ADDENDUM NO. 3

DATE: March 13, 2020

OWNER: Howard County Public School System

PROJECT: Hammond High School Renovation and Addition
Columbia, Maryland
Architect Project No. 18011

SHEET TITLE:
FIRST FLOOR PLAN - AREA C - UNDERSLAB PLUMBING

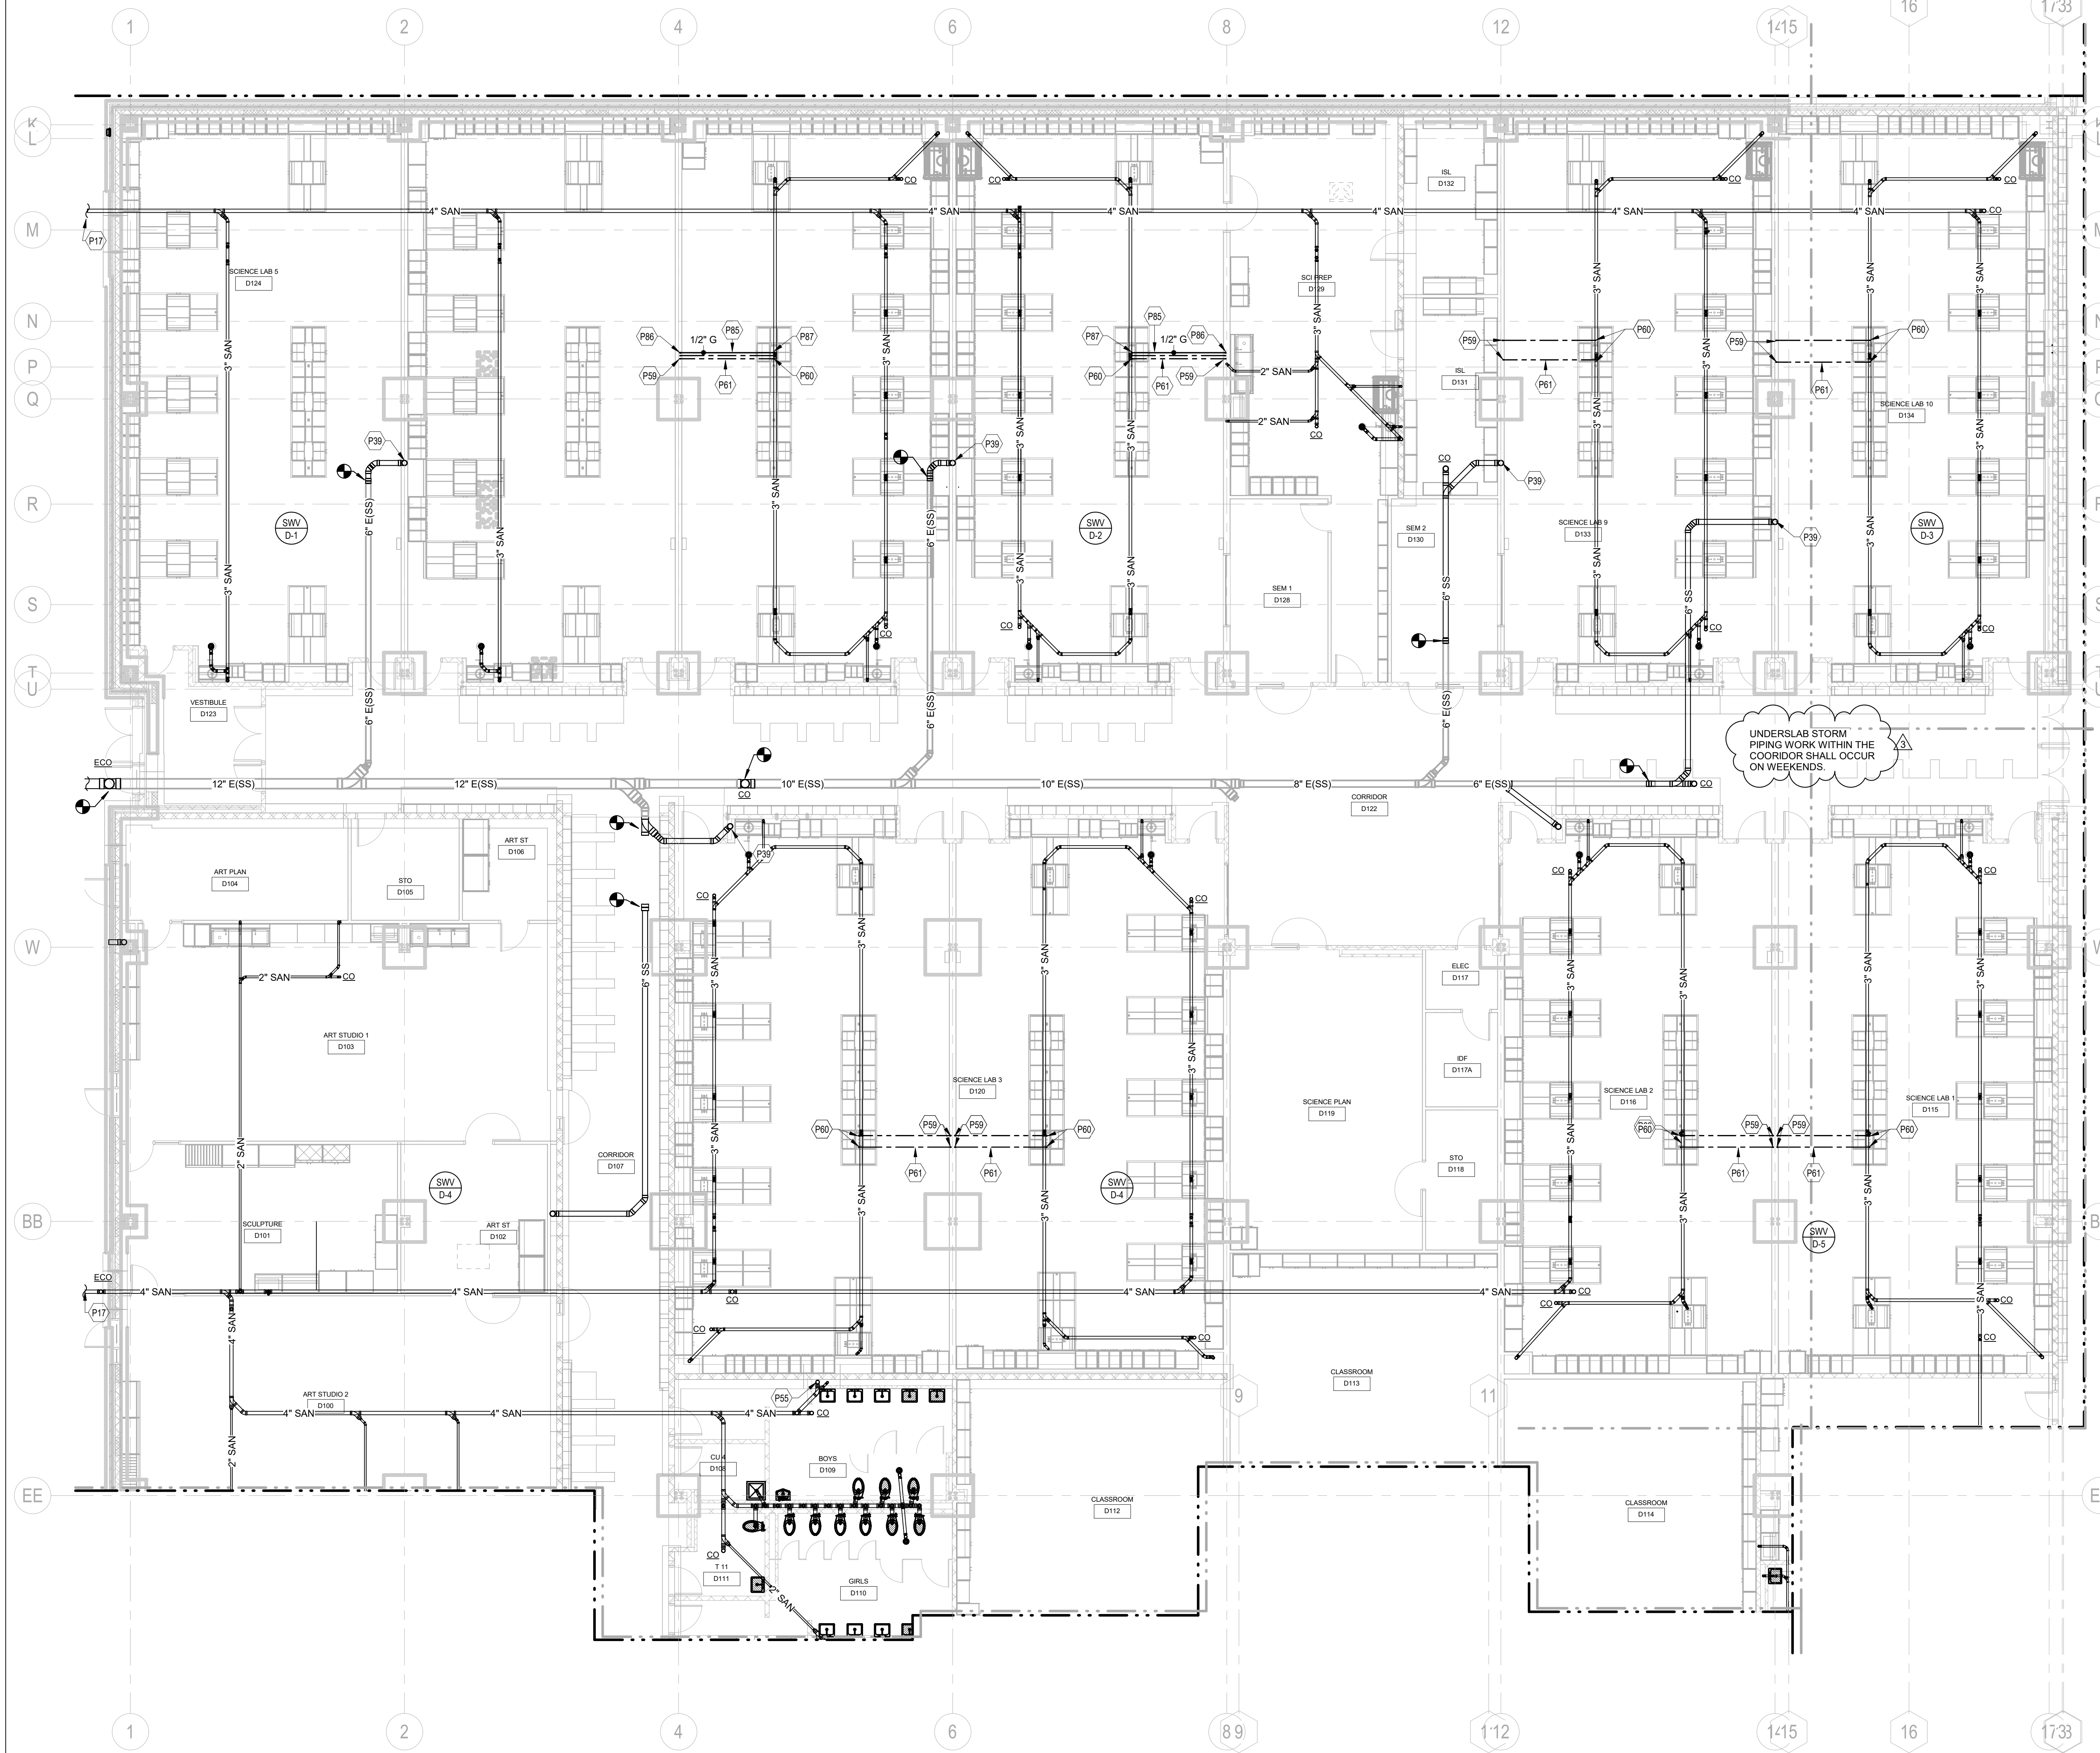
- **REVISE:** Storm piping existing the building, plan east, is 15" in lieu of 12".
- Sheet P3.03 – FIRST FLOOR PLAN – AREA C – UNDERSLAB PLUMBING
 - **REPLACE SHEET:** incoming water service size from 4" to 6". Refer to domestic water service entrance detail p1.01 for continuation. Revised storm piping.

2 RADON REDUCTION PIT DETAIL
 3/4" = 1'-0"

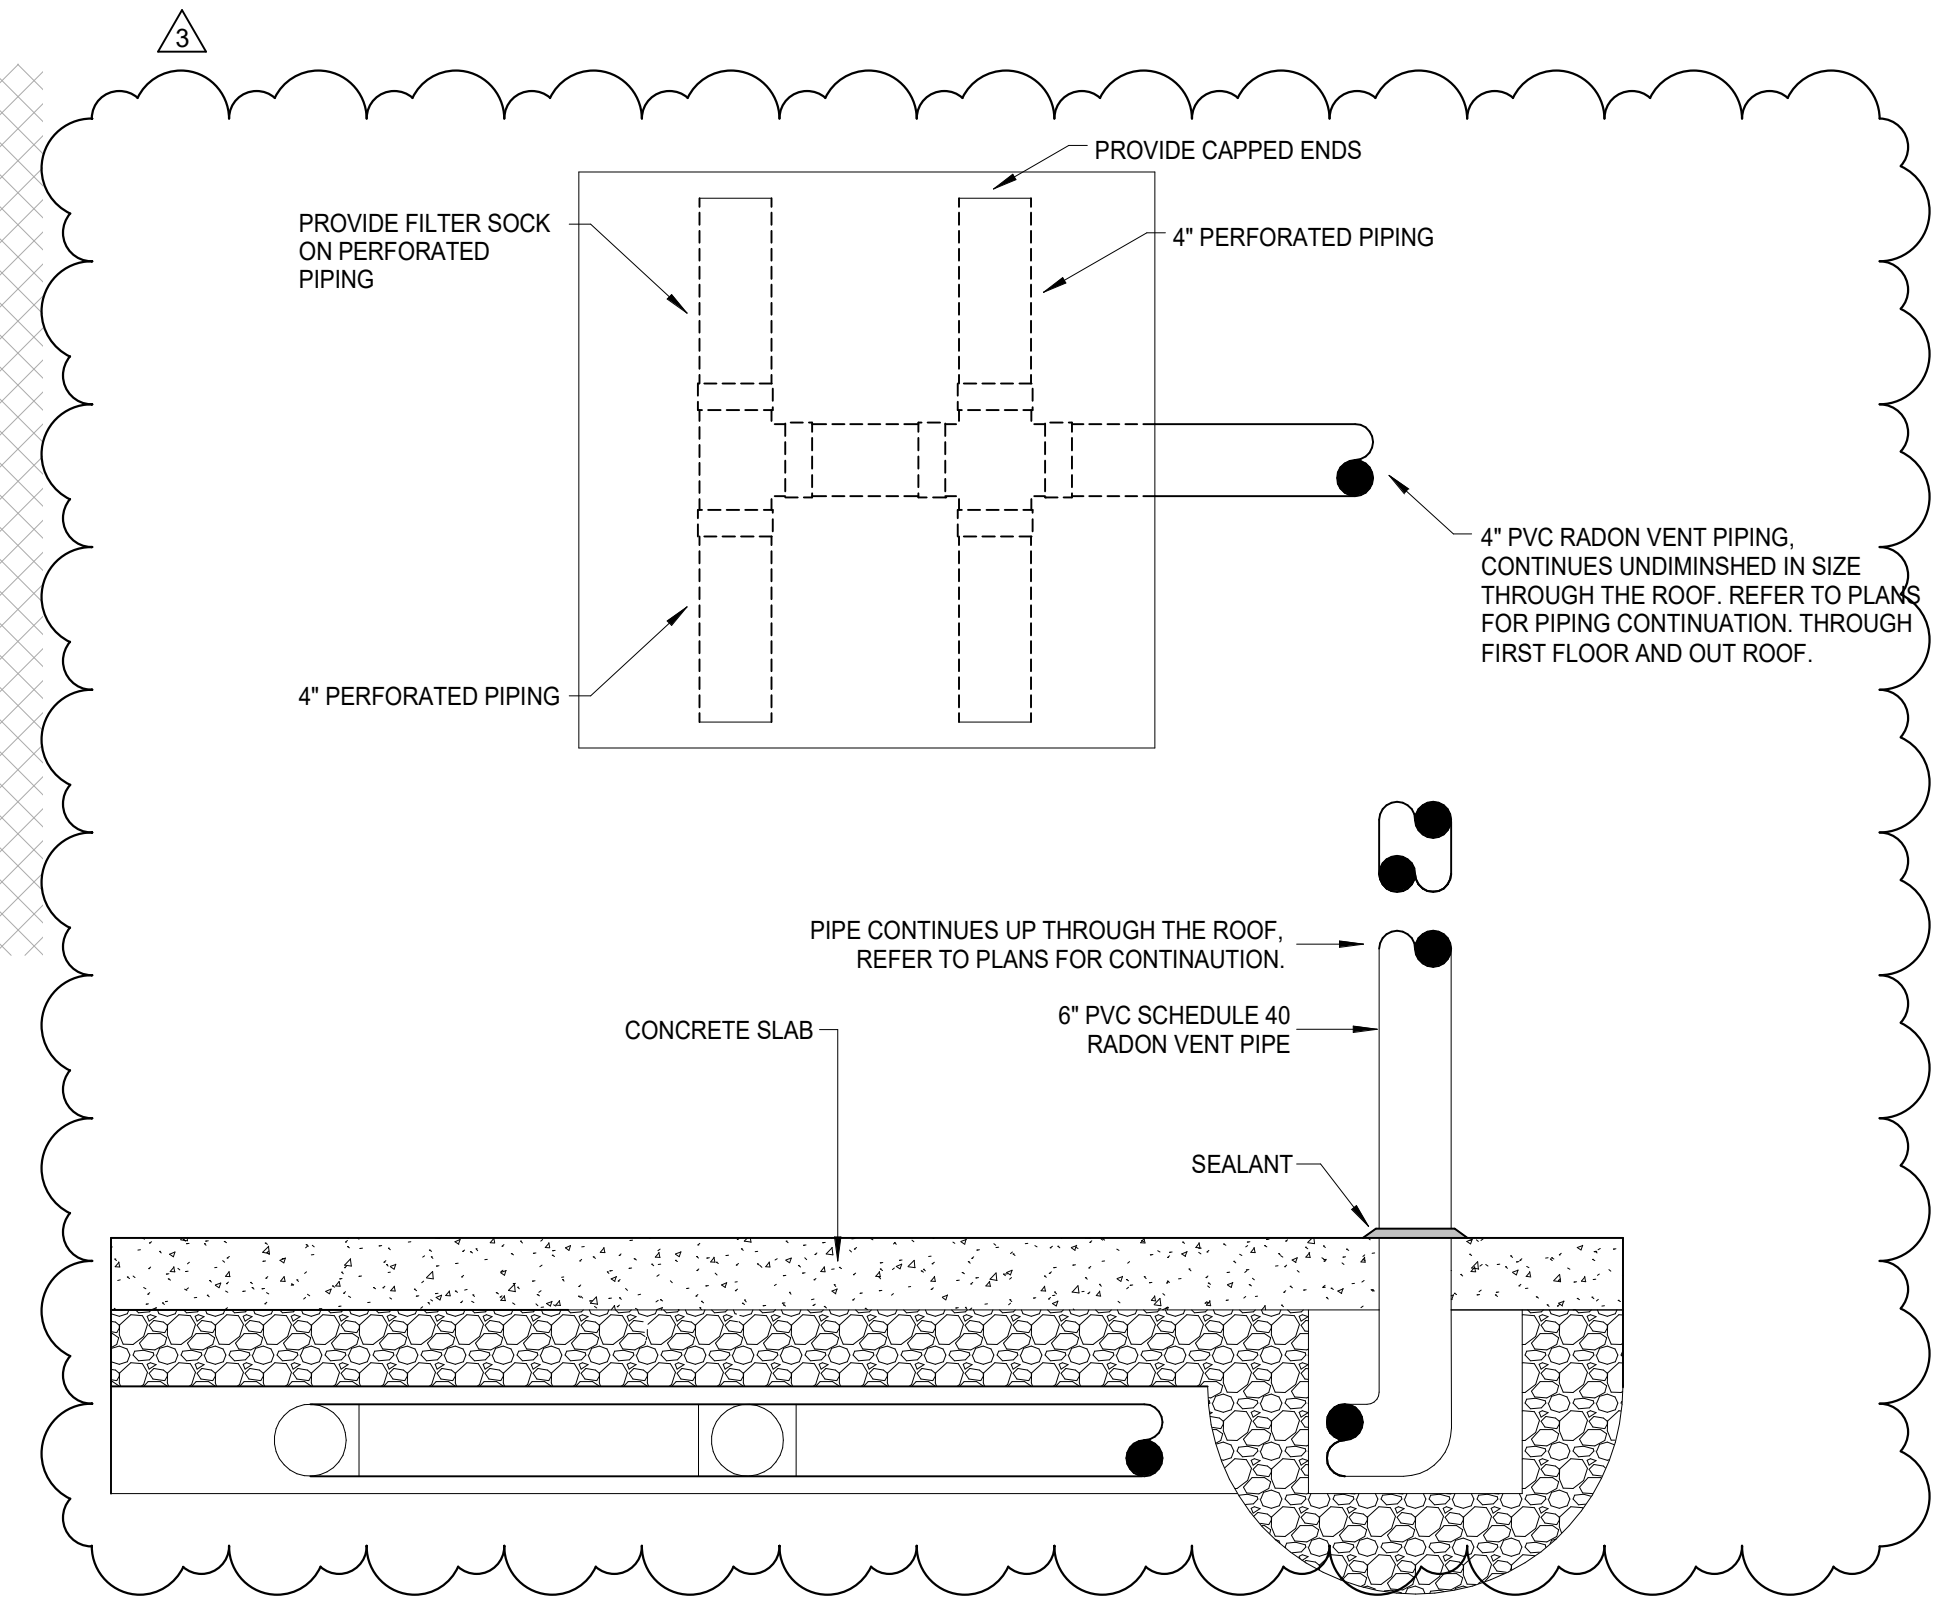
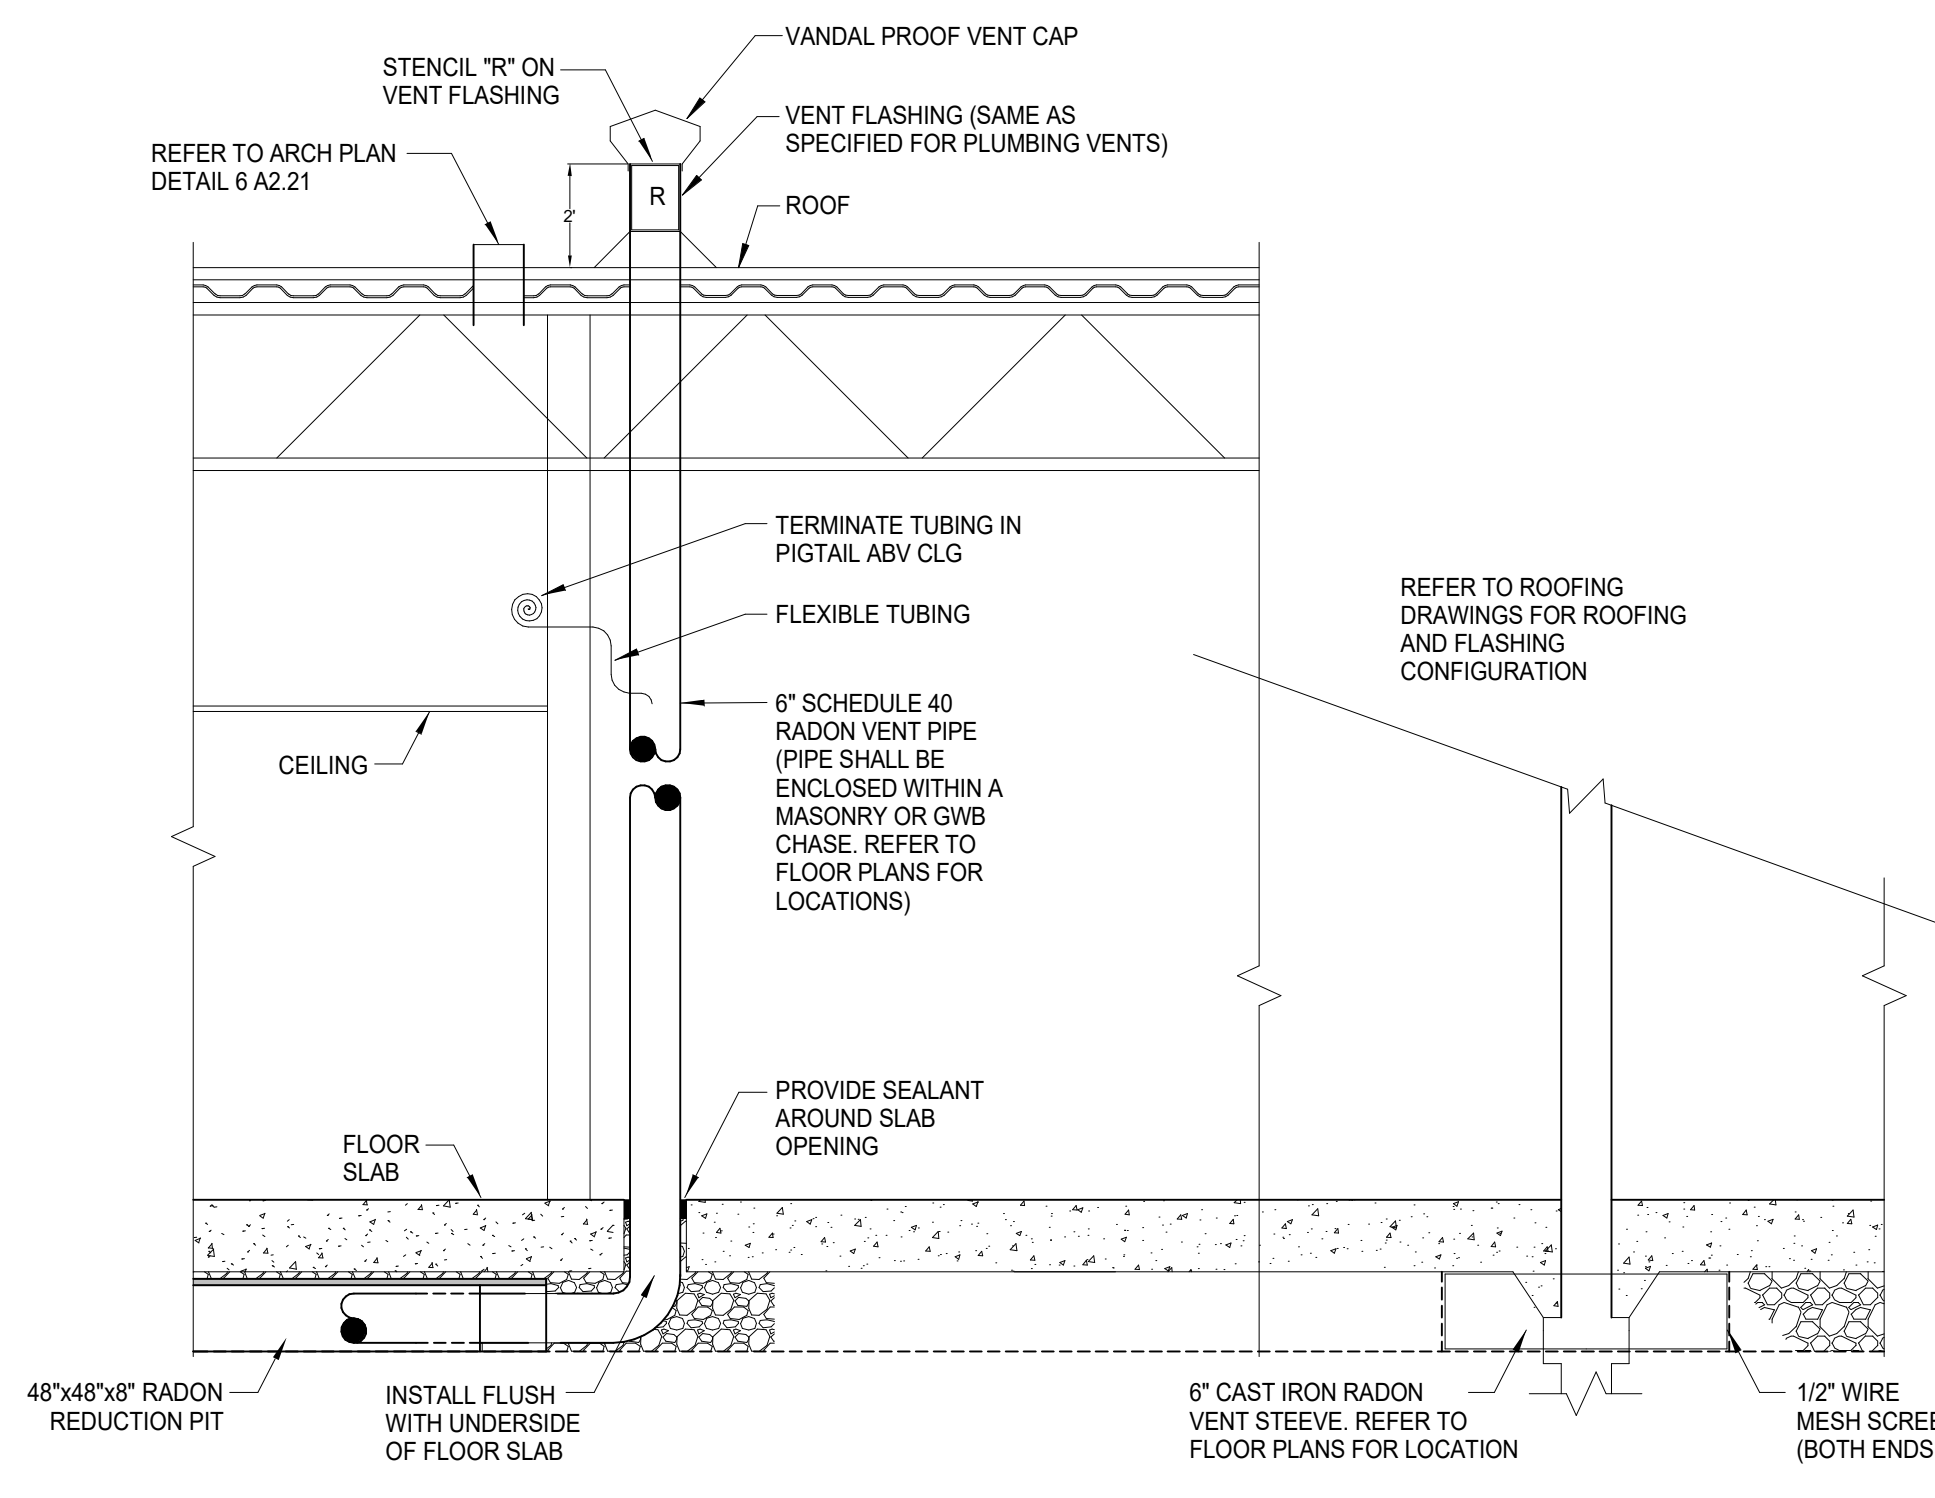
23. Drawing P 3.09, please clarify the following items:

- A. Please provide detail for radon reduction pit and what type of material is to be used.
- B. The detail on top of the page shows 4" perforated pipe in an "H" shape, is the intent for this to go inside radon reduction pit?

- **REPLACE SHEET:** Modified 15" SS routing.
- Sheet P3.09 – FIRST FLOOR PLAN – AREA G – UNDERSLAB PLUMBING
 - **REPLACE SHEET:** Modified a pipe sleeve. Added clarification to Radon Reduction Pit Detail.

RESPONSE: Refer to RADON REDUCTION PIT DETAIL on Replacement Sheet P3.09. The intent is for the "H" shape perforated piping to be installed inside the radon reduction pit.
